LOUISIANA
POWER & LIGHT

W3K84-0974
3-A1.01.04

SUBJECT: Waterford 3 Steam Electric Station
Docket No. 50-382
Construction Adequacy of WSES-3 Basemat

Attached are our responses to the questions. There are only minor changes, mostly of an editorial nature or in response to comments from the NRC staff.

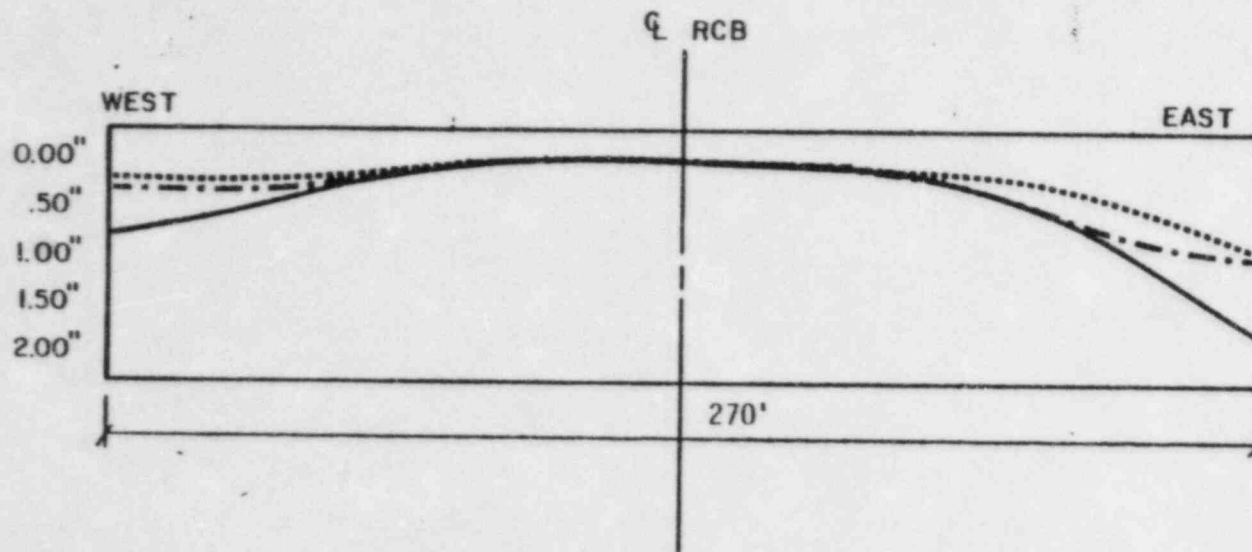
2. Where was water table when 1977 cracks were discovered?

At the time of discovery the ground water in the shell fill beneath the mat was at about elevation -20 ft. or about 15 feet above the top of the mat. (FSAR Figure 2.5-113: "Piezometer, Heave Point and Extensometer Responses Sh. 3 of 5).

SK-1564-15.10-G-25.1
SK-1564-15.10-G-26.1
SK-1564-15.10-G-27.1
SK-1564-15.10-G-28.1
SK-1564-15.10-G-29.1
SK-1564-15.10-G-30.1
SK-1564-15.10-G-35.0
SK-1564-15.10-G-35.1

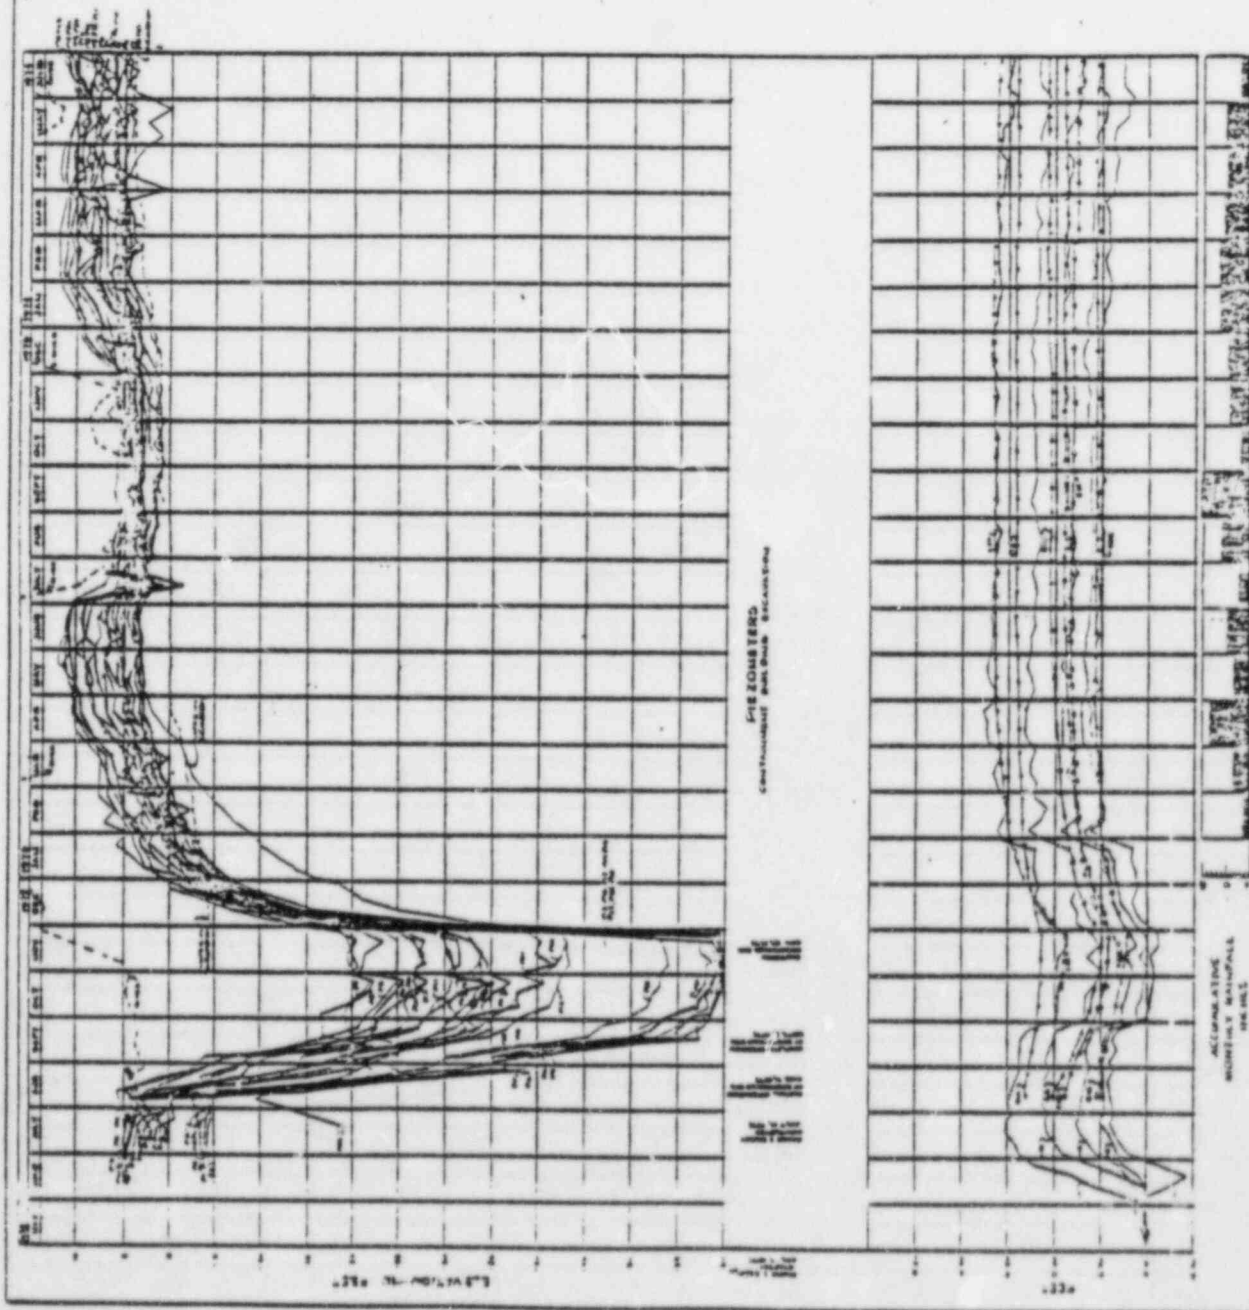
4. Provide X-Section maps of mat flexure over time period zero to present.

The following sketches reflect the mat by block and point settlement as monitored. Two full size copies were provided for NRC staff use at the March 26, 1984 meeting in Bethesda, Maryland.

SUPPLEMENT TO NCR W3-535

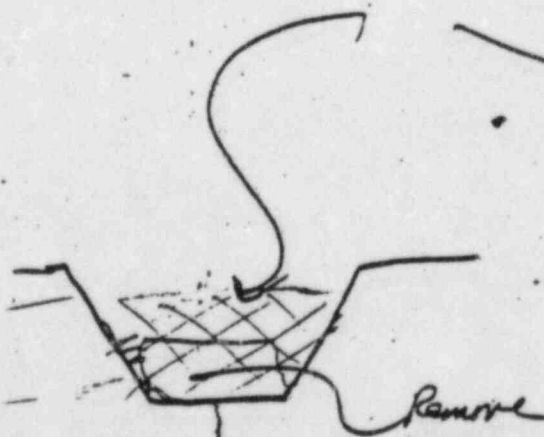
The top of the mat beneath the containment structure contains a number of cracks which were discovered to be weeping water. The rate of weeping is generally enough to show the crack and to moisten the surrounding concrete. It appears that these radial cracks are the result of the concave shape which the material has assumed due to differential settlement.

After an unsuccessful attempt at pressure injecting epoxy grout into the cracks, the following procedure should be used to effectively control the leakage or weeping of water through the cracks.

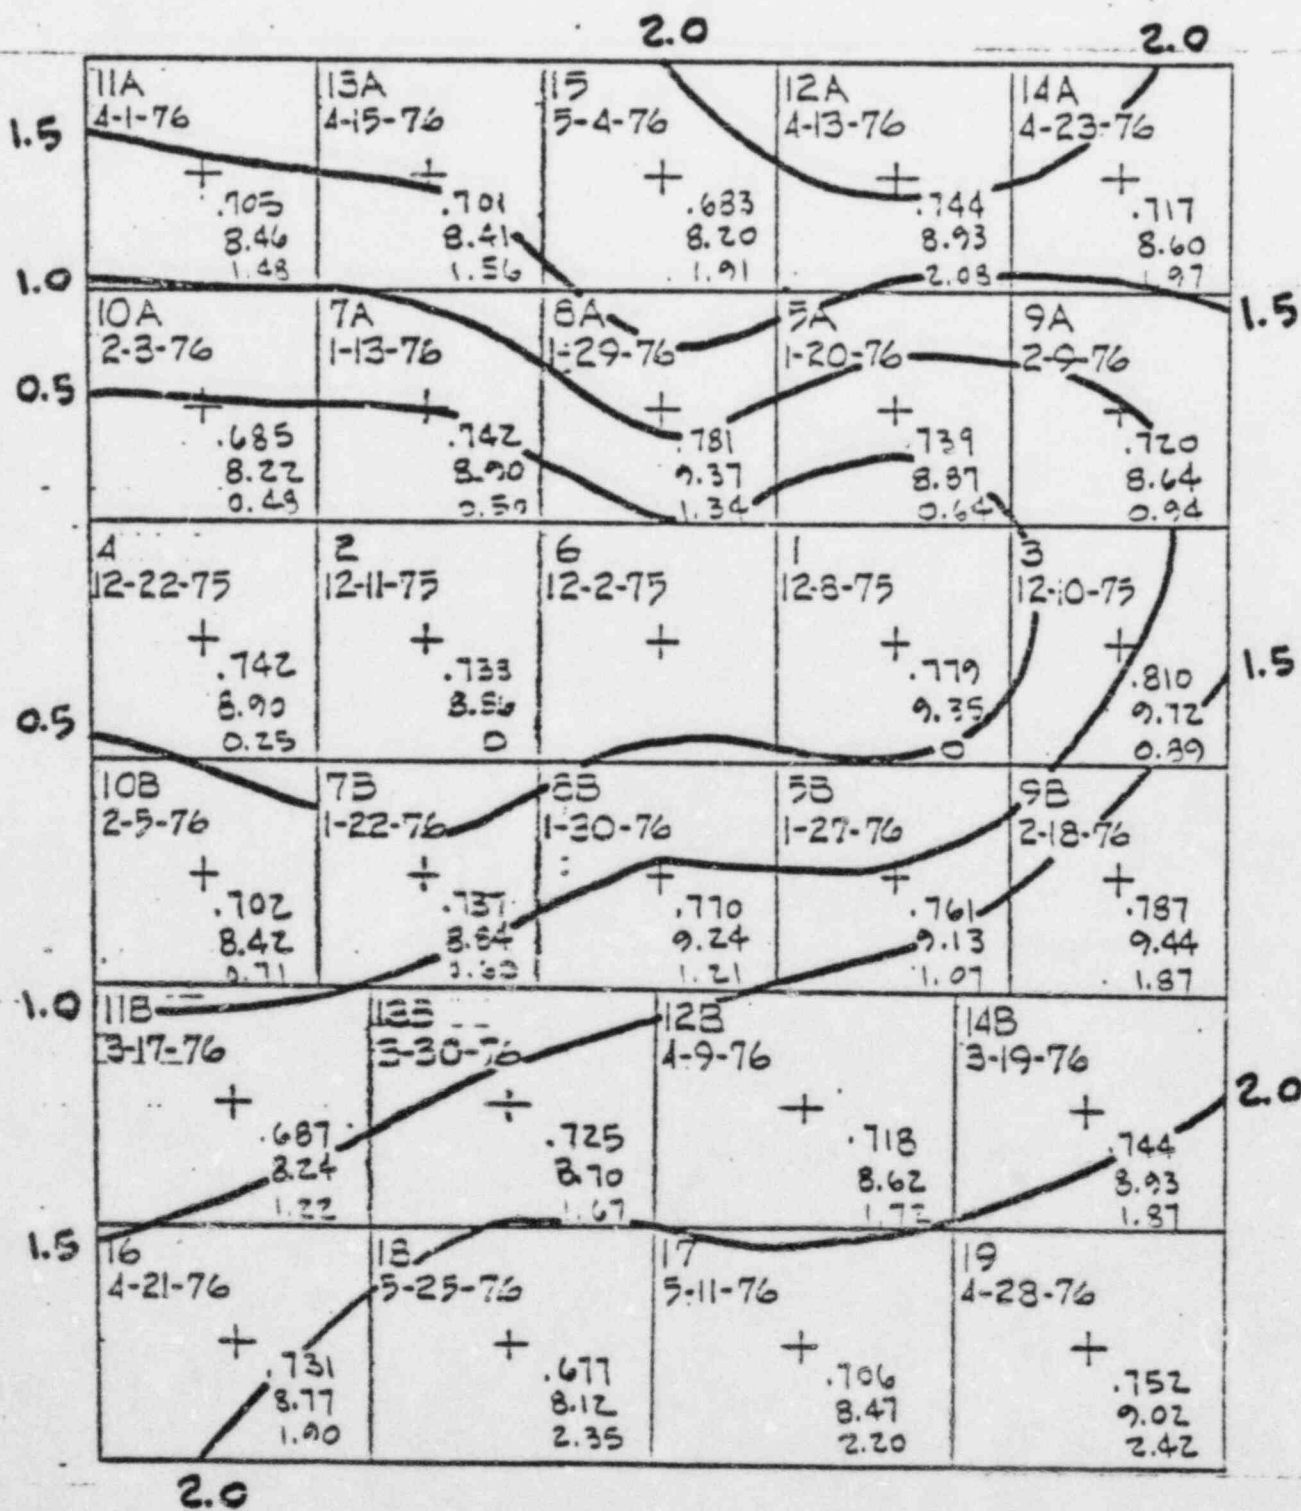
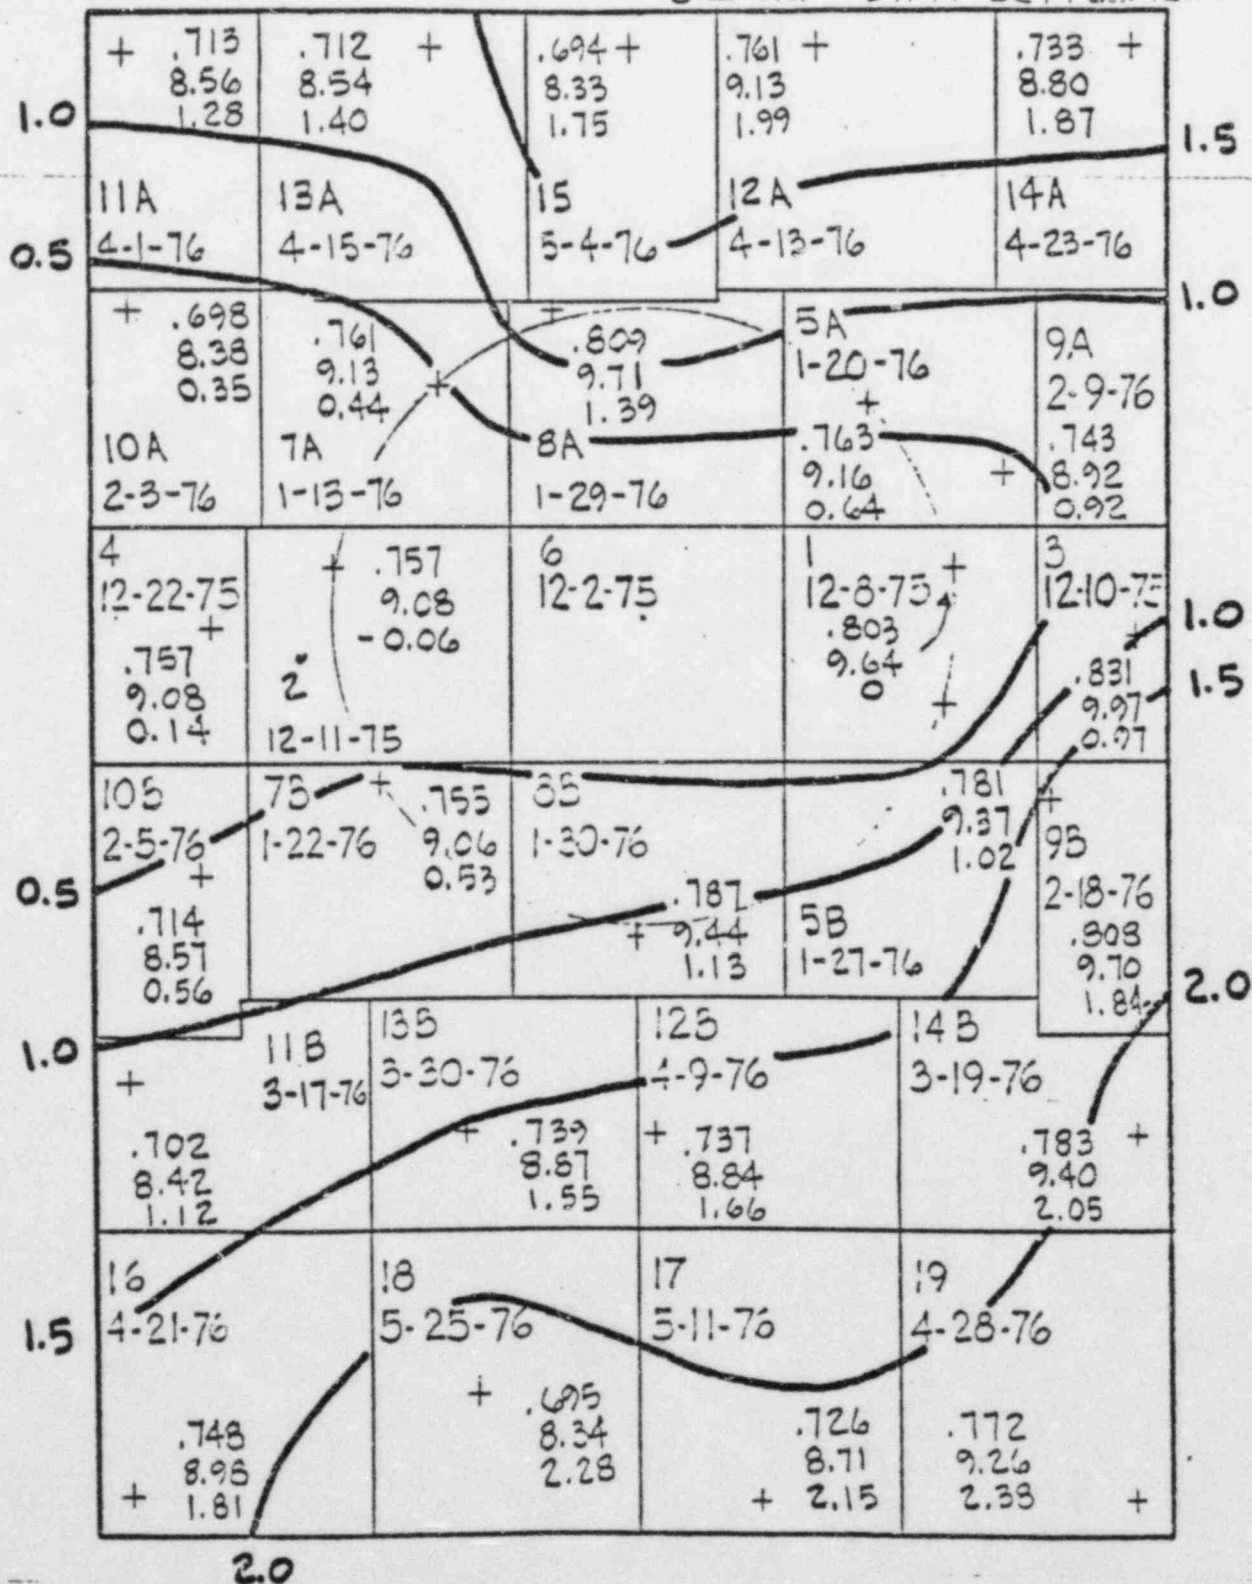
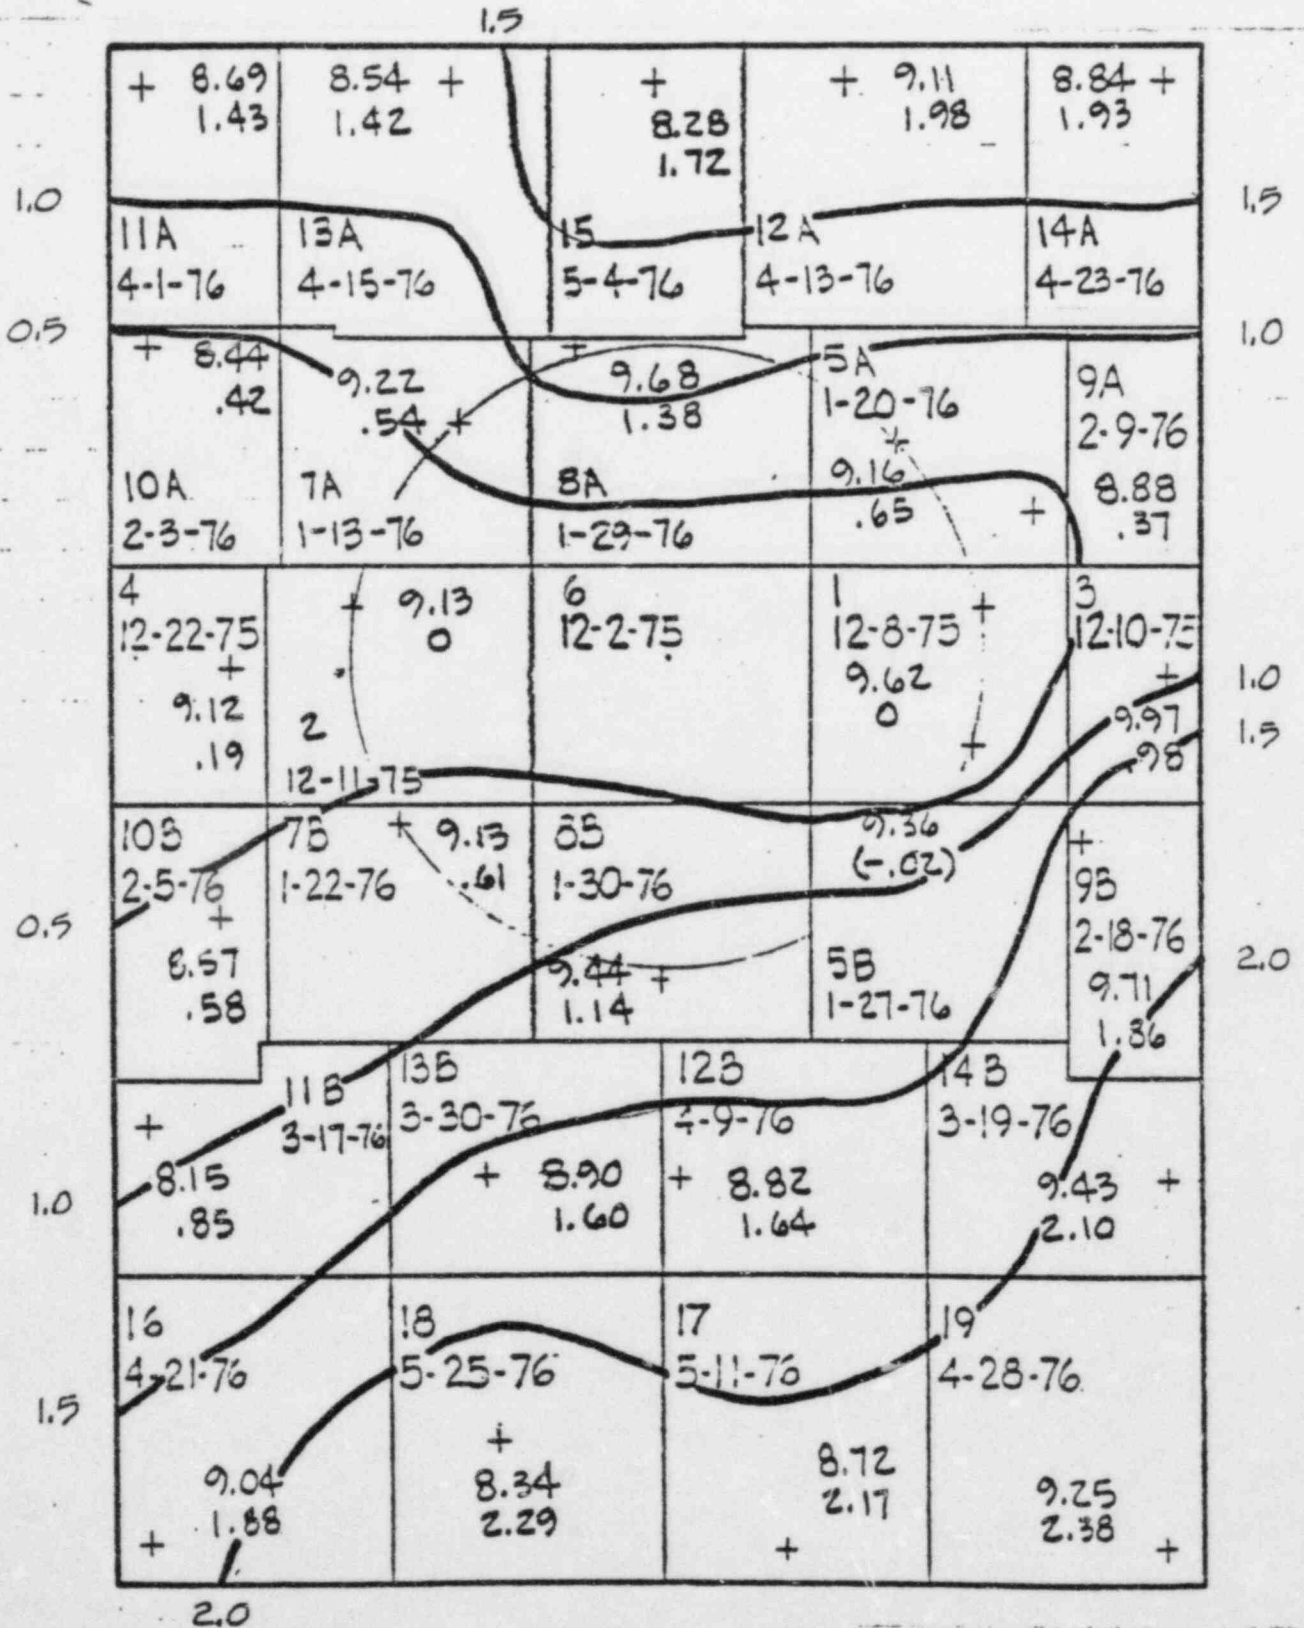
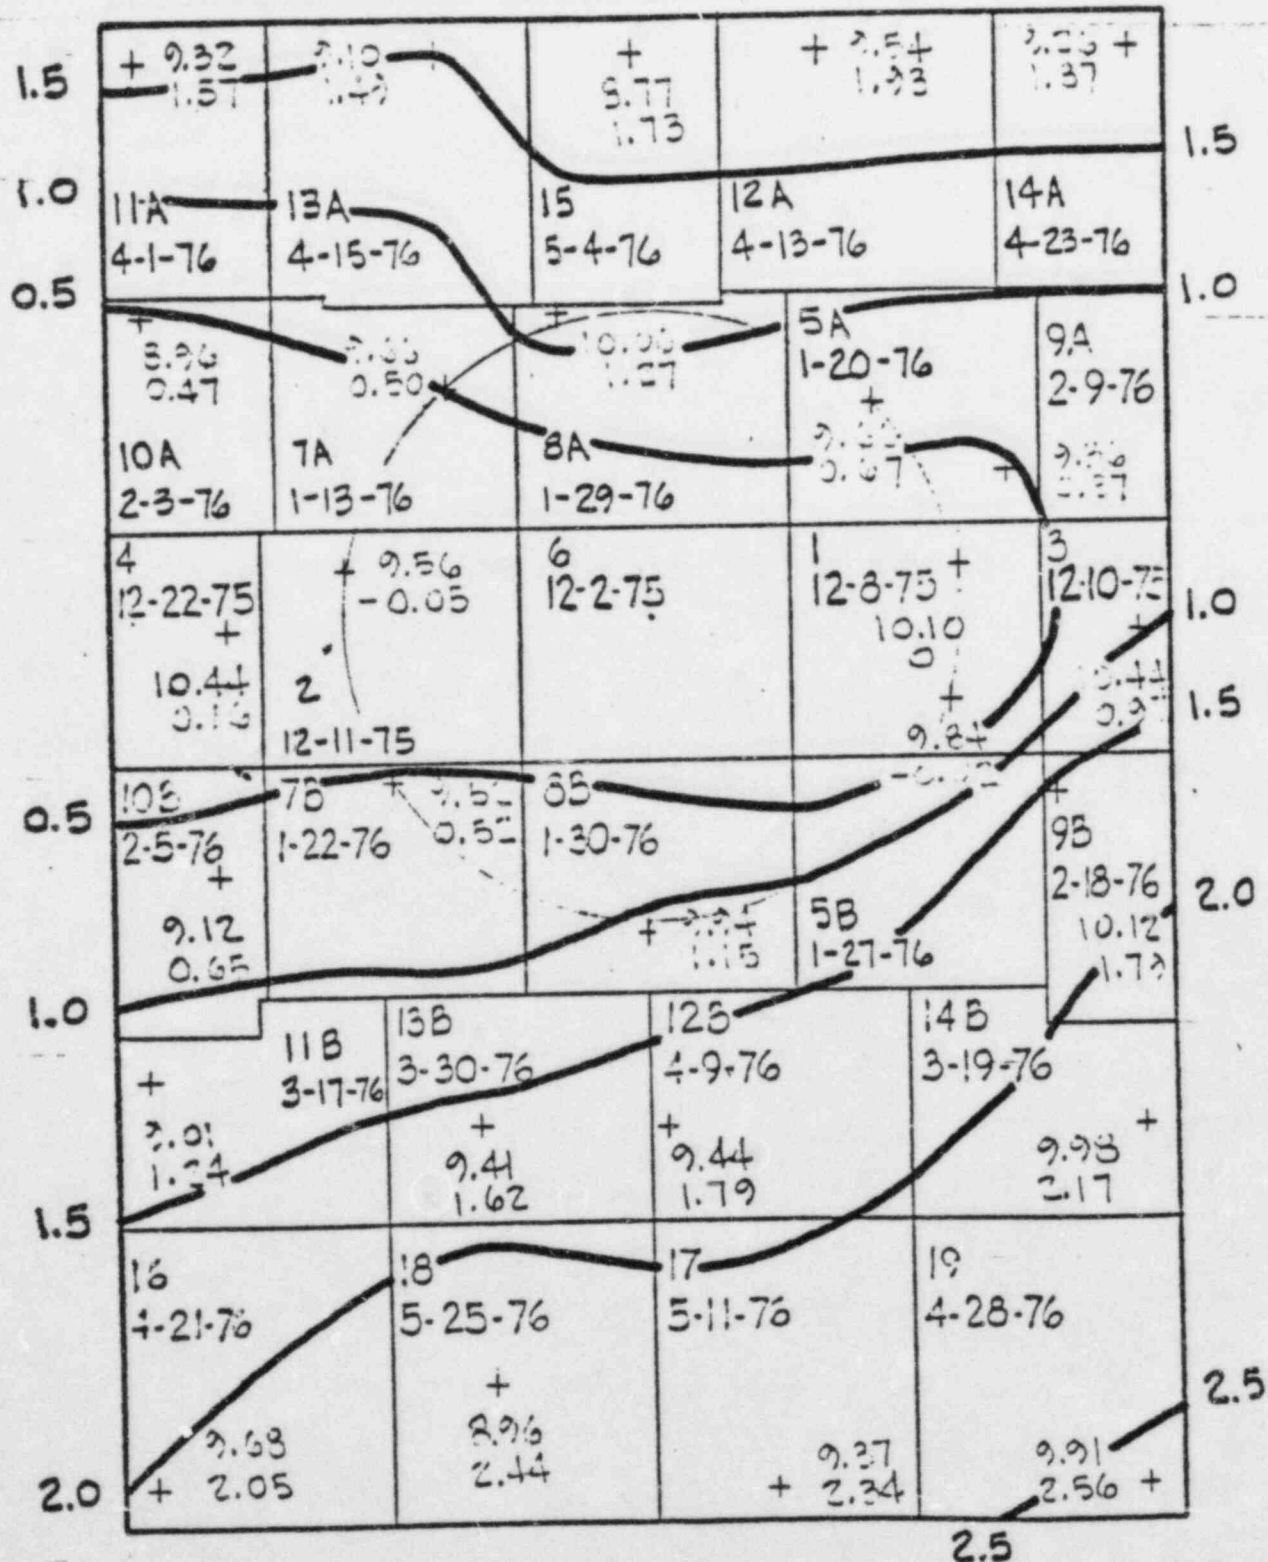
17. Provide differential settlement contours for 6 month periods, starting from early 1977 to present.
